# Brighton Council

MINUTES OF THE PLANNING AUTHORITY MEETING  
OF THE BRIGHTON COUNCIL HELD  
IN THE COUNCIL CHAMBER, COUNCIL OFFICES  
OLD BEACH AT 5.30 P.M. ON TUESDAY,  
14 DECEMBER 2021

##### 5.1 Development Application DA 2021 / 00199 for Multiple Dwellings (14) at 15 Morrison Street, Brighton:

**Figure 2 Site Plan (Source: MinD)**

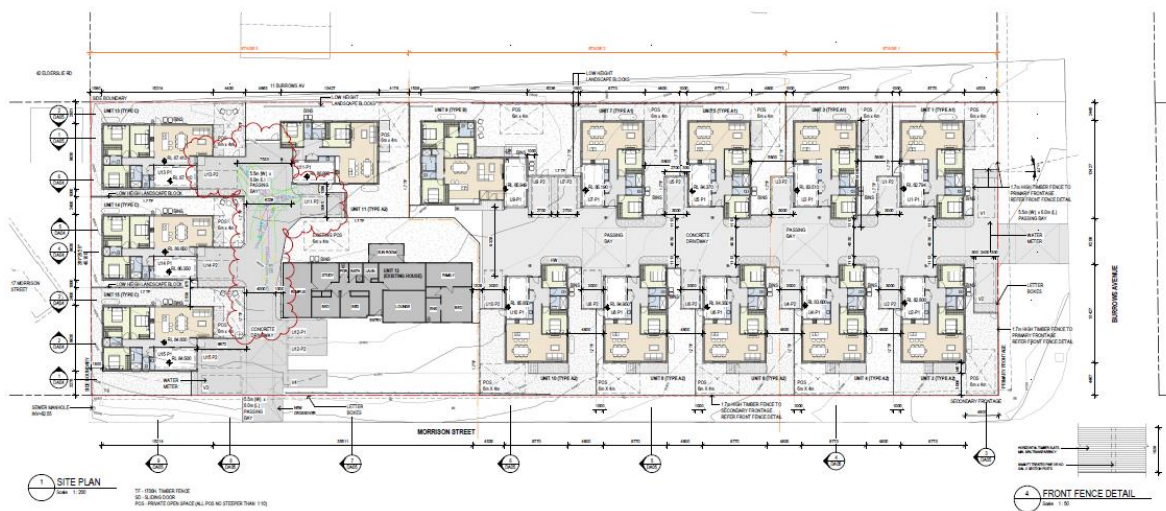
An assessment of the parking layout against Acceptable Solution A1.1 (a) is provided below:

- i. The gradients comply with the relevant requirements of AS2890 (i.e. less than 15-20%).
- ii. The swept path demonstrates that cars can enter and leave the site in a forward direction.

- iii. Table C2.2 requires an internal access width not less than 5.5m. The access widths are 5.5m at the two main access aisles that connect to Morrison Street and Burrows Avenue.

- iv. Table C2.3 requires parking dimensions of 5.4m length x 2.6m width with combined access and manoeuvring width of 6.4m for 90-degree parking. Some of the parking spaces do not comply with the aisle width requirements. **Therefore, the performance criteria must be relied upon to satisfy the standard.**

- v. Some of the combined access and manoeuvring widths do not comply. **Therefore, the performance criteria must be relied upon to satisfy the standard.**

The proposal does not meet A1.1 (a) or (b) so must be assessed against P1.

Regarding AS 2890/, the TIA states that, apart from some of the isle widths (manoeuvring areas adjacent to parking spaces) being slightly less than 5.6m, the parking layout generally complies with the Australian Standard. Engineering plans and swept paths have been provided which demonstrate that the manoeuvring areas are sufficient to facilitate a B85 vehicle into and out of the spaces without conflicts. According to the TIA, this ability is due to the additional space width and the low-speed operating environment.

The proposal provides does not provide a 1m wide footpath in accordance with A1.1 (a). Therefore, assessment against the performance criteria is relied upon to satisfy the standard. This assessment is provided below.

*Cr Geard moved, Cr Curran seconded that this item be held over until the Ordinary Council meeting on the 21<sup>st</sup> January 2021, pending discussion with the developer in relation to providing on-site pedestrian safety access.*

**Advice: Parking aisle widths less than those stipulated in AS2890.1 may be accepted where turning paths demonstrate vehicles can enter and exit parking spaces.**
